Objections Part 3 : PLN2019-00368 and the CDRC meeting March 12, 2020

CDRC meeting March 12, 2020

PLN2019-00368

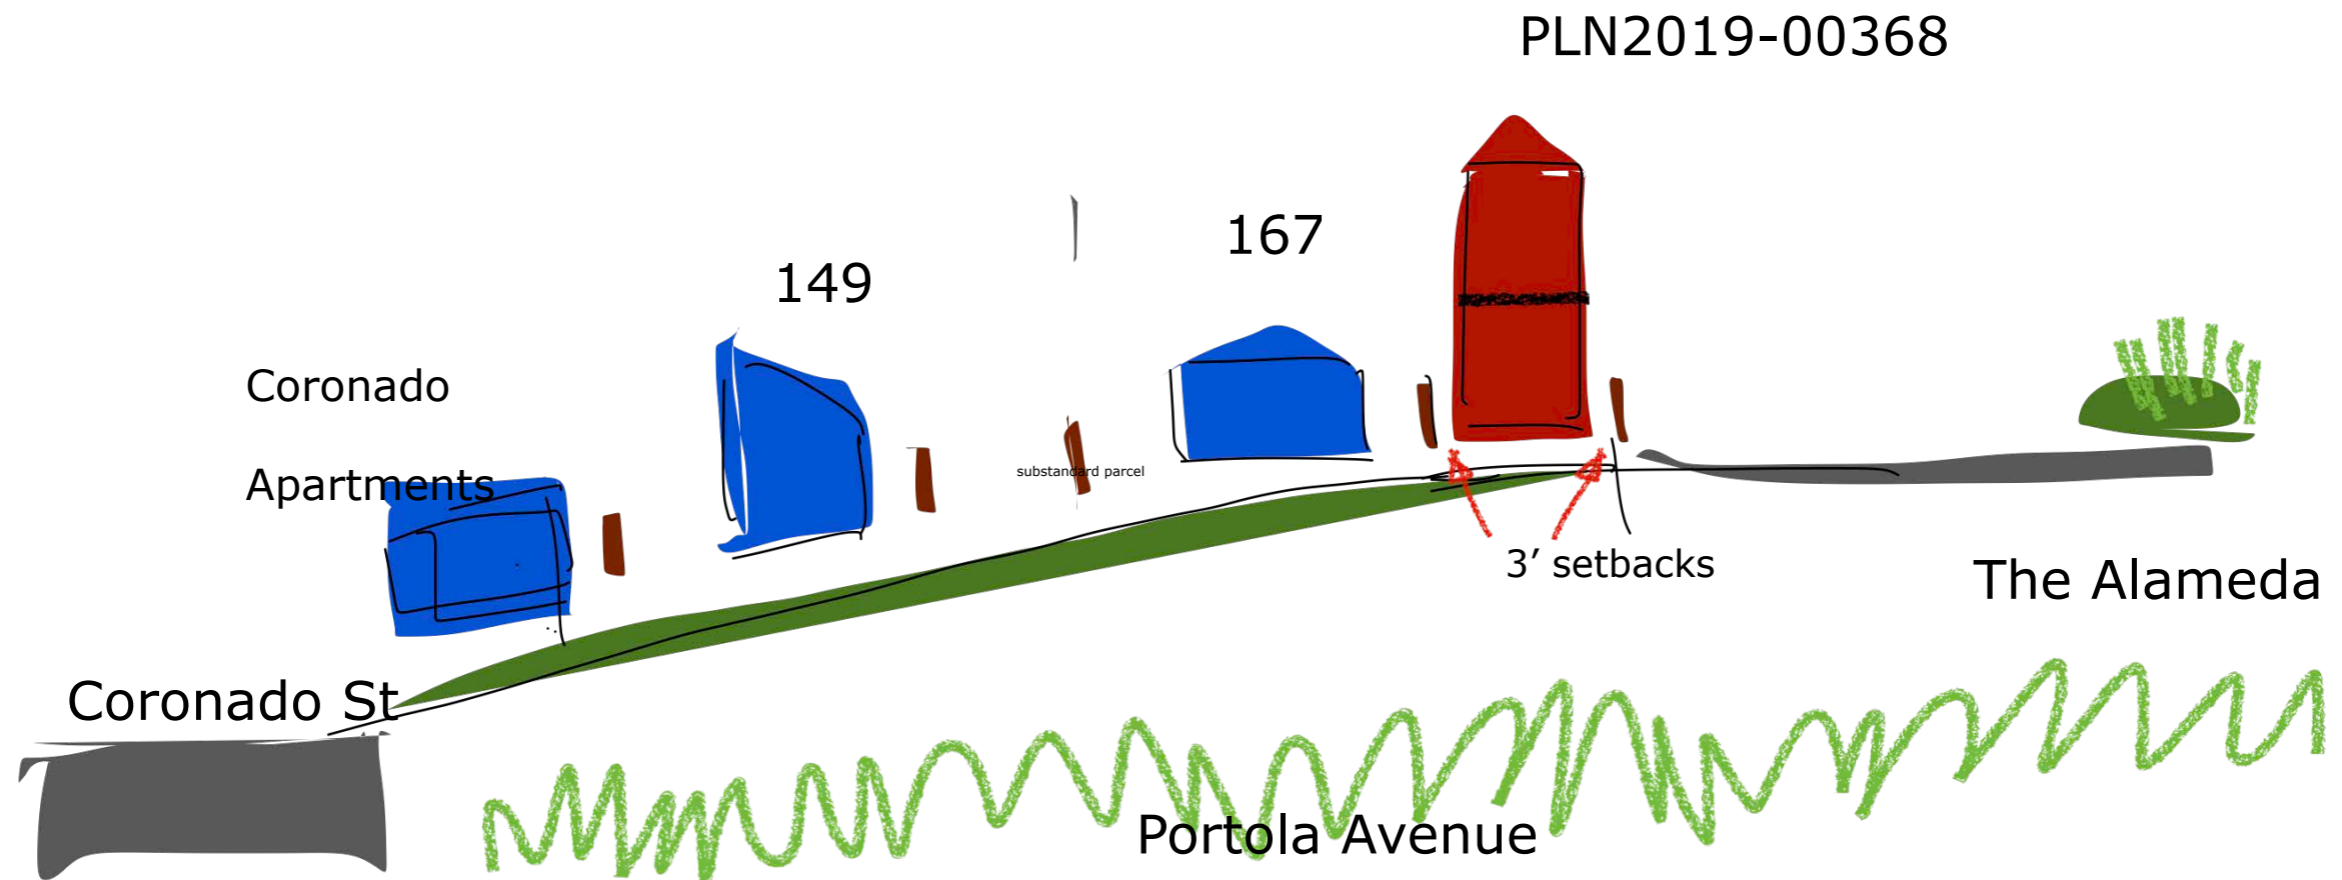
6408.1 applies according to our Coastside commissioner in the Planning Commission, Lisa Ketcham, and it specifies the rules for a CORNER LOT according to which the side towards the 167 Portola cottage should be 5, and the side towards The Alameda, should be 10'.

Clearly the rules for a corner are important, because it influences the whole intersection. This project would sit 7' closer to The Alameda than regulations prescribe if the use permit is allowed. Nothing sits that close to The Alameda. And it would sit 3' instead of 5' from 167 Portola.

At the March 12 meeting, the parcel is described by Bruce Chan as 'difficult' and Dough Machado as 'tough', but they are not going to dispute the footprint; that by avoiding zoning regulations, it was increased 90 %, from 10' x 80' to 19' x 80', sitting with only 3' side setbacks instead of 5' and 10'!

MISCHARACTERIZATION: "ESSENTIALLY A ROW OF DUPLEXES"

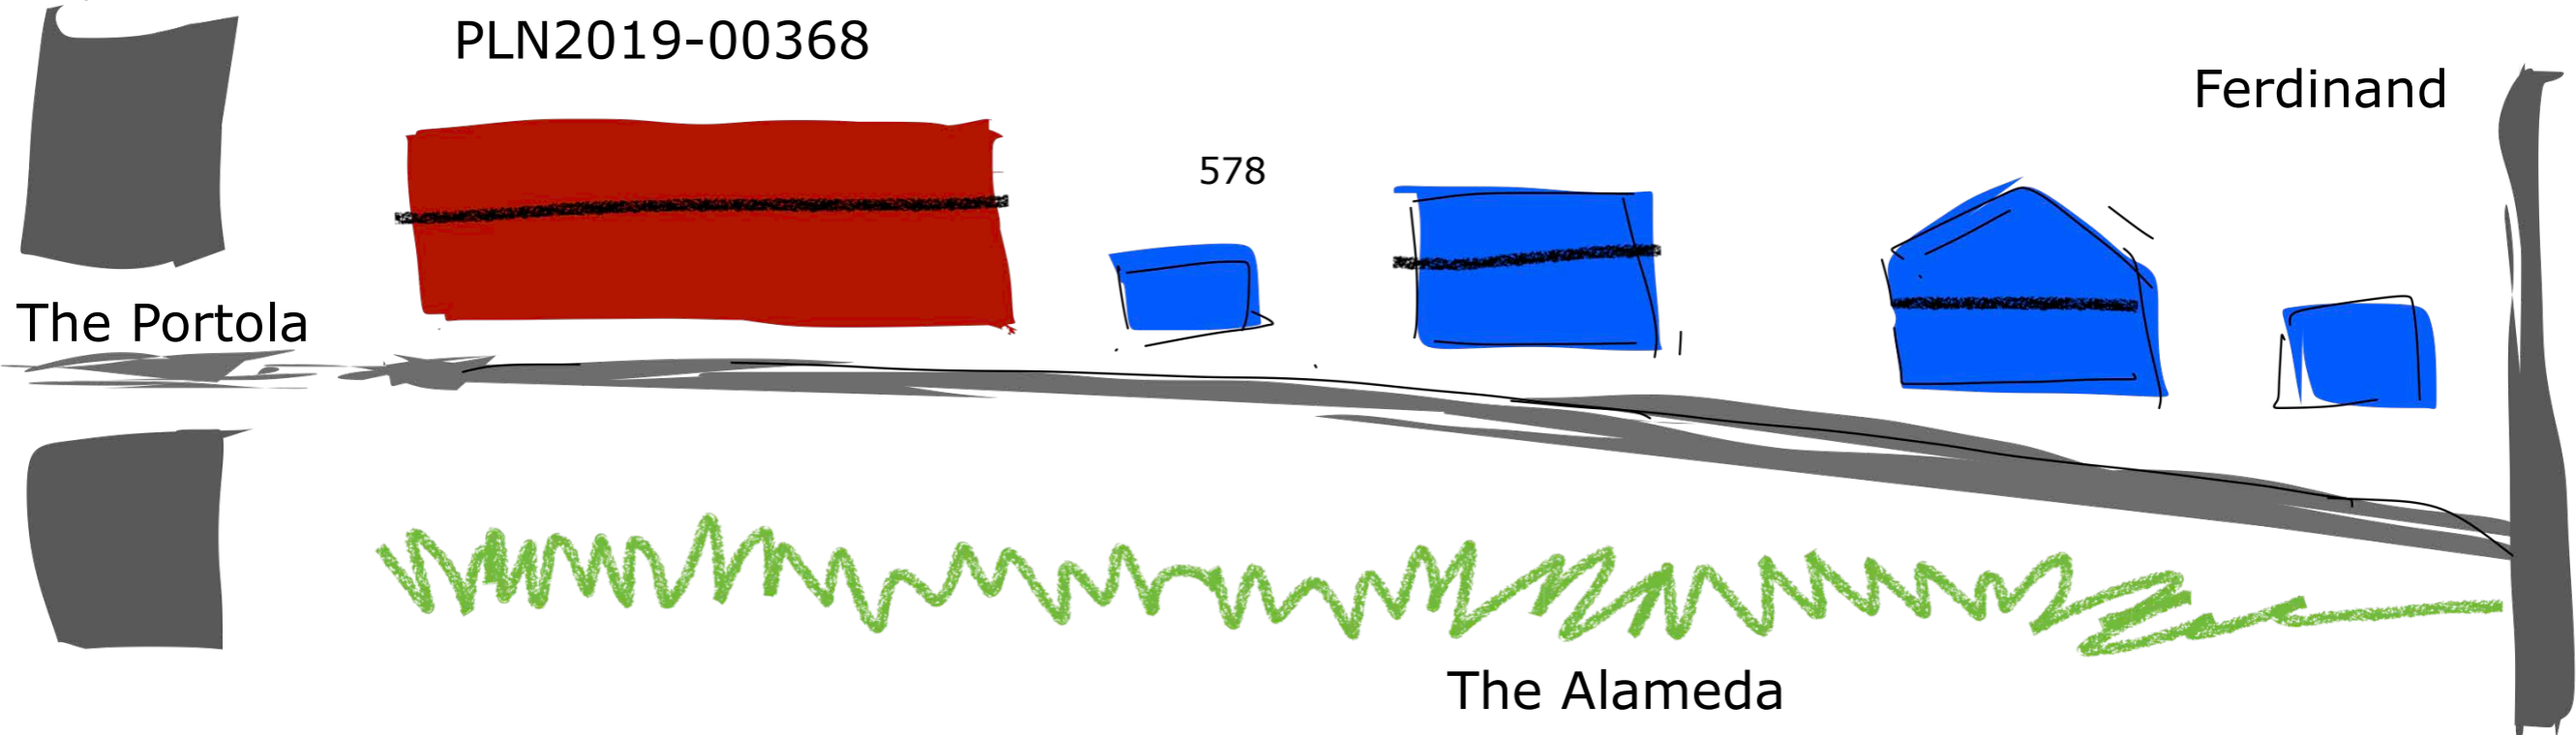
The El Granada alternate representative, Doug Machado, characterized our neighborhood as a 'essentially a row of duplexes' at the March 12 meeting:

"In the Design Manual shapes, scale, size of neighborhood. It's essentially a row of duplexes down that street, you'll have this one at the end. So it is not an anomaly, that's what the street...So it being weird doesn't necessarily turn me off to the style because of that."

Below is the block, not in scale, but just to make it clear: There are only one-story buildings going down Portola Avenue. Next door to the proposed at 167, is a one story cottage from 1950 that was bought by a young couple last year! 149 was built last year, it is two modest single story buildings. The Coronado apartments are 5 small single story buildings along Coronado street.

Both from the point of view of Portola and The Alameda, the project is at the top of a rise. It's next door neighbors are one story. All the structures on the Portola block are one story. On The Alameda the buildings that are two stories, duplexes, are more integrated in the slope going down. You cannot dismiss the neighborhood as a 'row of duplexes'.

The proposed project is 23' x 80' and thus presents a facade that is almost 4 times as long as it is high. Nothing comparable exists in the neighborhood. It comes off as very domineering. It sticks up sitting 23' high on a rise, and with the setback of 3' it also sticks out towards The Alameda. It looks like a big bully next to the little cottage on 167 Portola and 578 Portola.

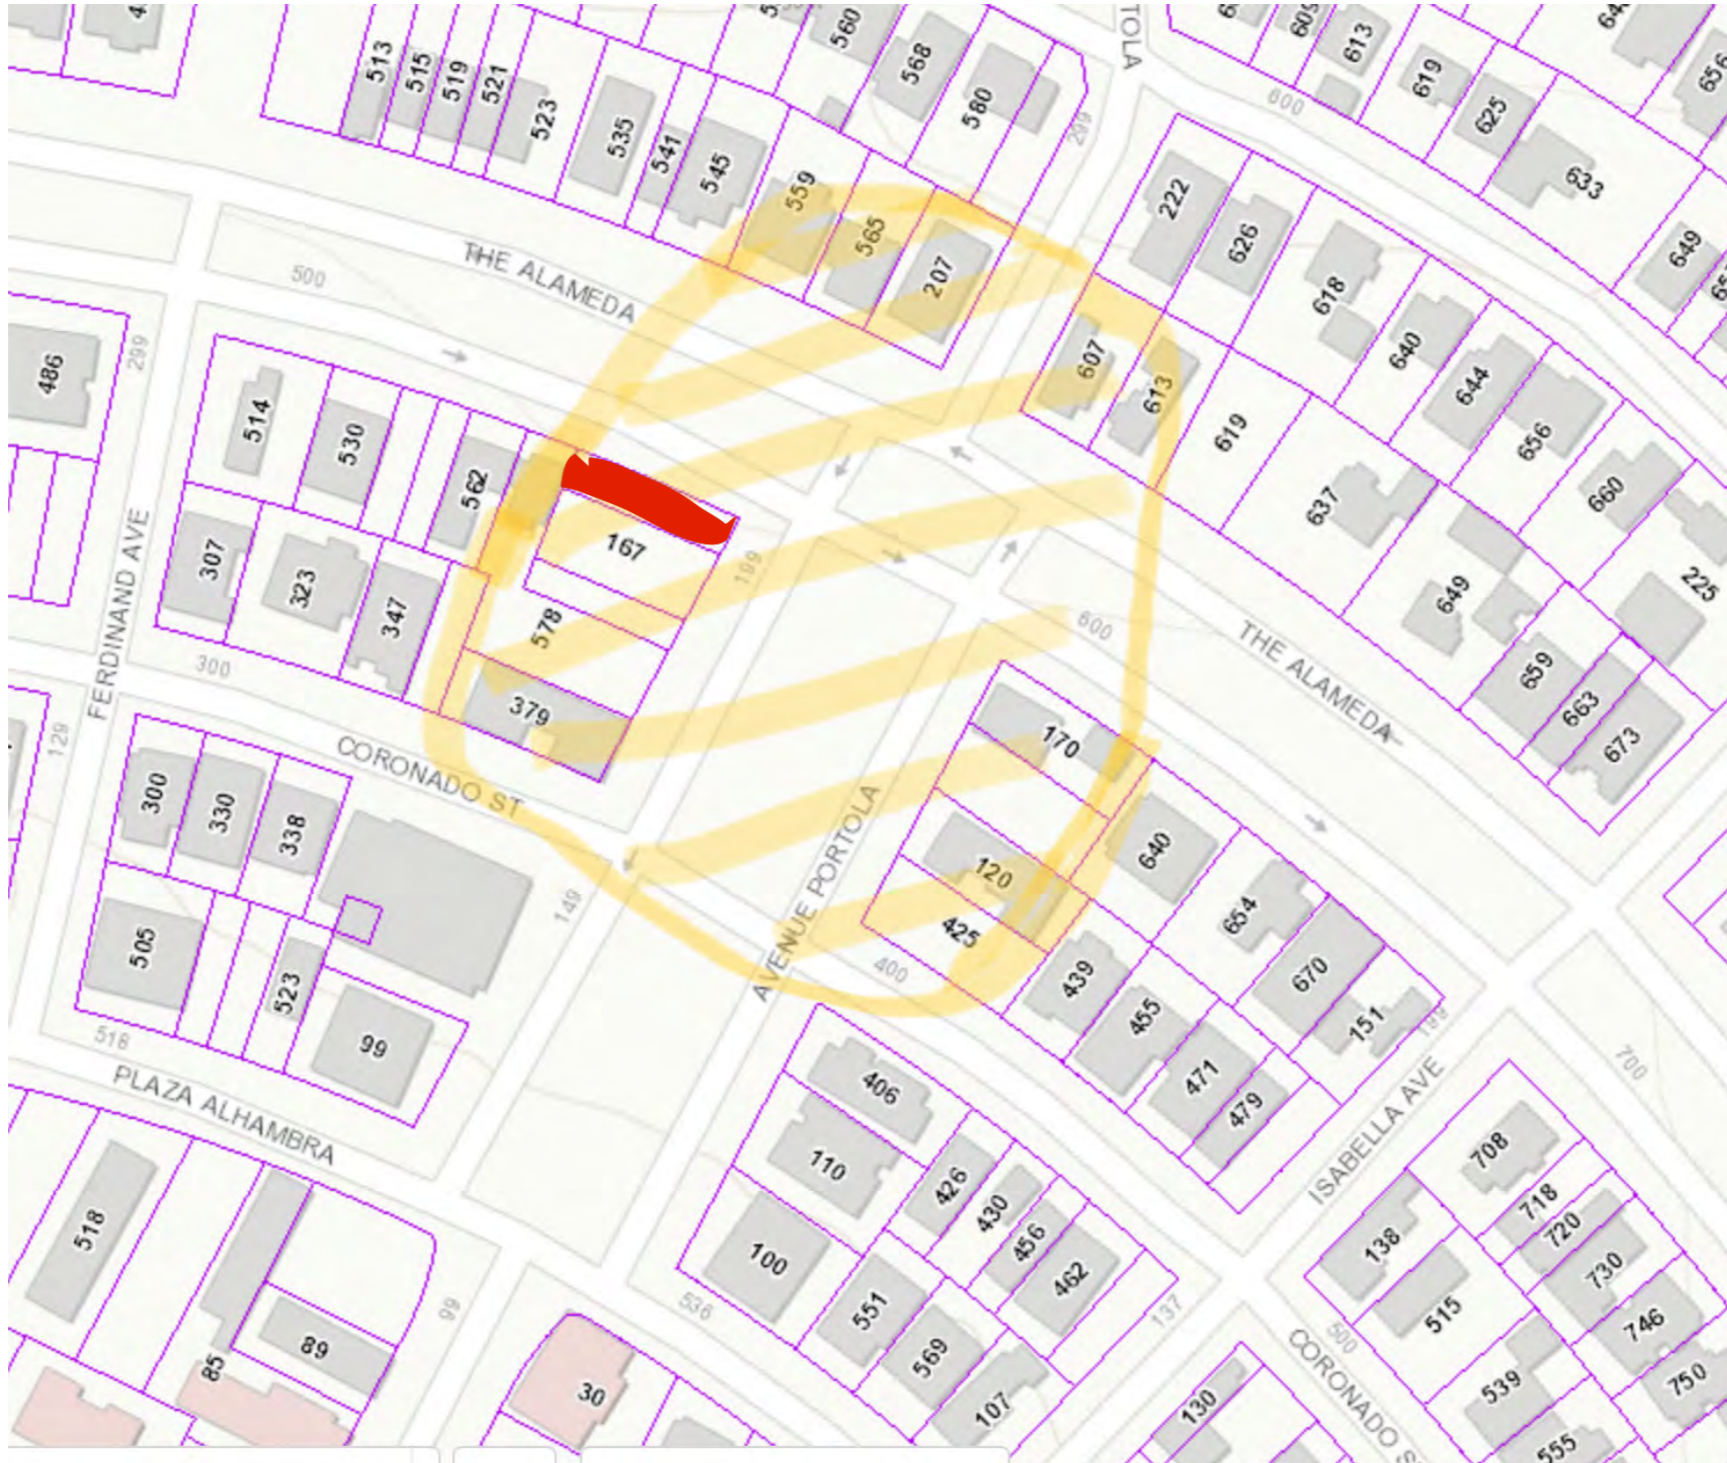
New and enlarged homes should respect the scale of the neighborhood through building dimensions, shape and form...

One story designs are strongly encouraged in areas where one-story homes are predominant

Design structures that are in scale with the character of their setting and blend rather than dominate or distract from the overall view of the urban landscape. 8.13a(4)
